2023/1971/P – 47 Alma Street, NW5 3DH

Delegated Report		Analysis sheet		Expiry Date:	11/07/2023
(Members' Briefing)		N/A		Consultation Expiry Date:	09/07/2023
Officer			Application Number(s)		
Kristina Smith			2023/1971/P		
Application Address			Drawing Numbers		
47 Alma Street London Camden NW5 3DH			Refer to Draft Decision Notice		
PO 3/4	Area Team Signature	C&UD	Authorised Officer Signature		
Proposal(s)					
Erection of ground floor and first floor extensions and alterations to existing fenestration					
Recommendation(s):		Grant Conditional Planning Permission			
Application Type:		Householder

Address:
47 Alma Street
London
Camden
NW5 3DH

Figure 6: Proposed first floor plan.

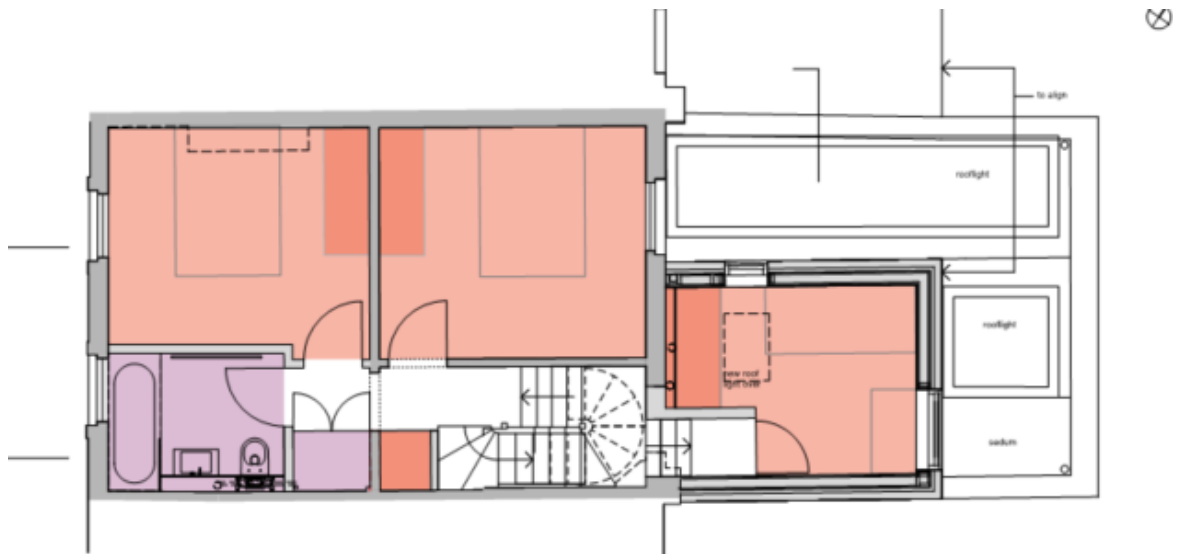
3.8. The property currently has no extension at first floor level unlike the vast majority of properties along the rest of the terrace. As such, the principle of an extension in this location is acceptable but dependent on scale, form and detailed design.

3.9. At a depth of 3.7m and a width of 3.2m, the proposed first floor extension (as revised) would match the first floor rear extension at no.46 Alma Street. The proposed extension would also match its height of 2.9m, creating a symmetrical pair in terms of massing.

3.10. It is noted that the proposed first floor element is less deep than the recently approved rear extension at number 51 Alma Street (ref. 2019/0756/P). Officers thought it appropriate to match the depth of the neighbour's extension from both a design and amenity perspective (see detailed discussion in later section).

3.11. The first-floor extension would be of brick construction and comprise a window facing the garden, a smaller north-west facing window and a modest rooflight. The windows would be aluminium framed, distinguishing the extension as a modern addition. This is considered to be an appropriate style and amount of glazing for this level on the building and would respect the solid to void ratios of similar extensions along the terrace.

1.2. During the course of the application, the first-floor extension was reduced in depth from 4.3m to 3.7m to match the depth of the first floor extension at no.46.

Second floor extension

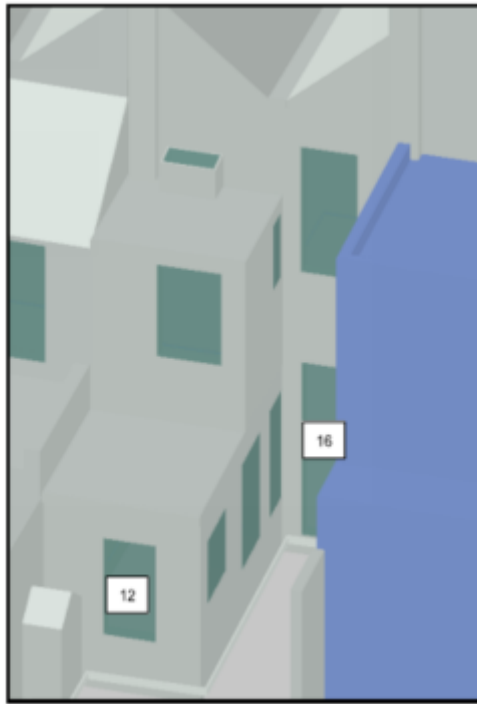
3.12. The alterations to the modern roof extension do not increase its visibility or general scale and replace unsympathetic glazing with equally unsympathetic glazing. Without a more substantial

reconfiguration of this extension, there is limited scope to improve its appearance. The rooflight to the existing flat roof would not be visible from ground level.
